SUBJECT: AMENDMENT NO. 109 TO FACILITY OPERATING LICENSE NO. NPF-30 -  
CALLAWAY PLANT, UNIT 1 (TAC NO. M93704)

AMENDMENT TO FACILITY OPERATING LICENSE

SAFETY EVALUATION BY THE OFFICE OF NUCLEAR REACTOR REGULATION

RELATED TO AMENDMENT NO. 109 TO FACILITY OPERATING LICENSE NO. NPF-30

FIGURE 3.9-1  
 MINIMUM REQUIRED FUEL ASSEMBLY BURNUP AS A FUNCTION  
 OF INITIAL ENRICHMENT TO PERMIT STORAGE IN REGION 2

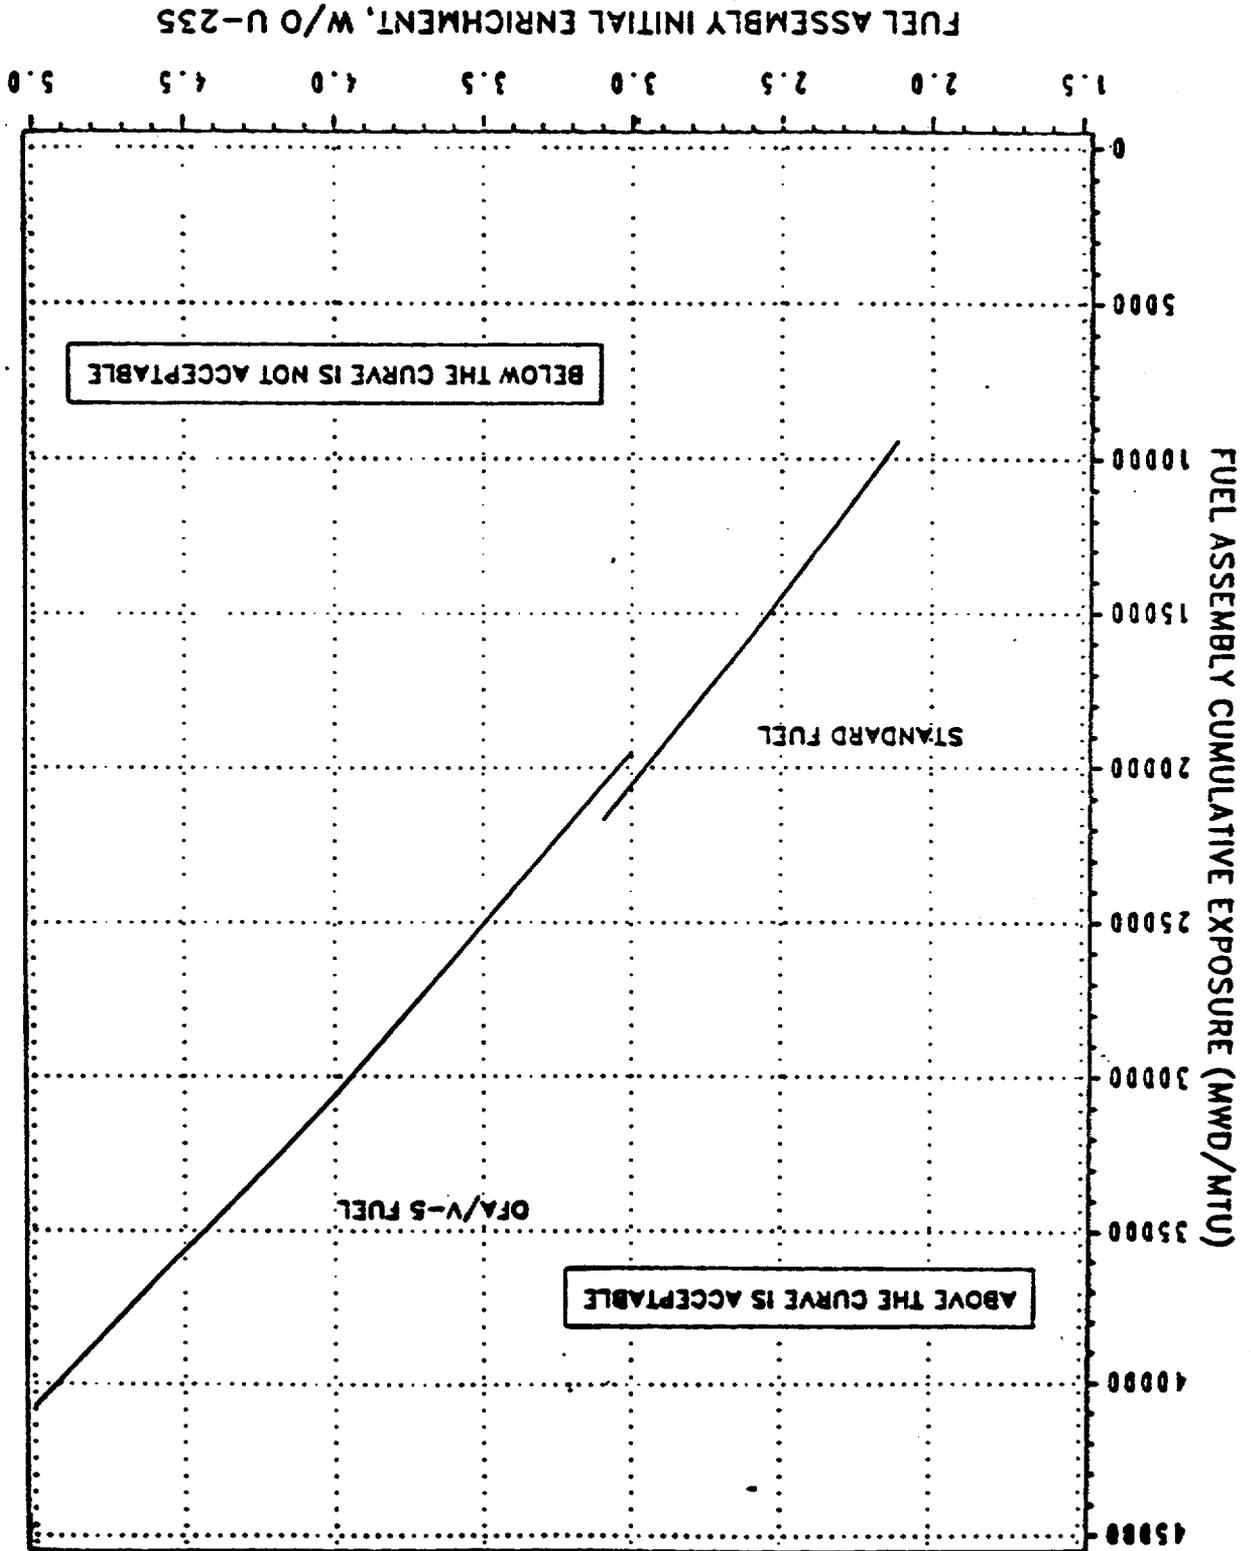
By letter dated September 6, 1995, as supplemented by letters dated January 30, 1996, March 27, 1996, and April 2, 1996, Union Electric Company (UE), requested changes to the Technical Specifications (Appendix A to Facility Operating License No. NPF-30) for the Callaway Plant, Unit 1. The proposed amendment would allow for the storage of fuel with an enrichment not to exceed a nominal 5.0 weight percent (w/o) U-235, subject to certain integral fuel burnable absorber (IFBA) requirements or discharge exposures, in the spent fuel pool storage racks. Plant operation using the higher enriched fuel will be demonstrated to be acceptable by a cycle specific reload safety evaluation performed prior to each fuel loading. TS 5.3.1, TS 5.6.1.1 and TS Figure 3.9-1 would be revised to incorporate the above changes.

Previously approved analyses performed for the Region 2 racks showed that acceptable criticality limits are maintained when storing fuel enriched to a maximum of 5.0 w/o U-235, provided that the fuel burnups meet the prescribed limits. However, due to thermal-hydraulic constraints, fuel enrichments only up to 4.45 w/o U-235 were allowed. These constraints have been resolved and the current spent fuel pool heat load methodology can be used to support storage of fuel up to a maximum initial enrichment of 5.0 w/o U-235.

- (1) TS 5.3.1 has been revised to reflect a change in the maximum initial enrichment to 5.0 w/o U-235 for reload fuel, subject to the IFBA requirements determined above, and to increase the maximum fuel enrichment not requiring IFBAs from 3.85 to 4.10 w/o U-235.
- (2) TS 5.6.1.1 has been revised to increase the maximum reference  $K_{\infty}$  from 1.455 to 1.480 for storage in Region 1.
- (3) TS Figure 3.9-1 has been revised to reflect a maximum initial enrichment of 5.0 w/o U-235 for storage in Region 2.
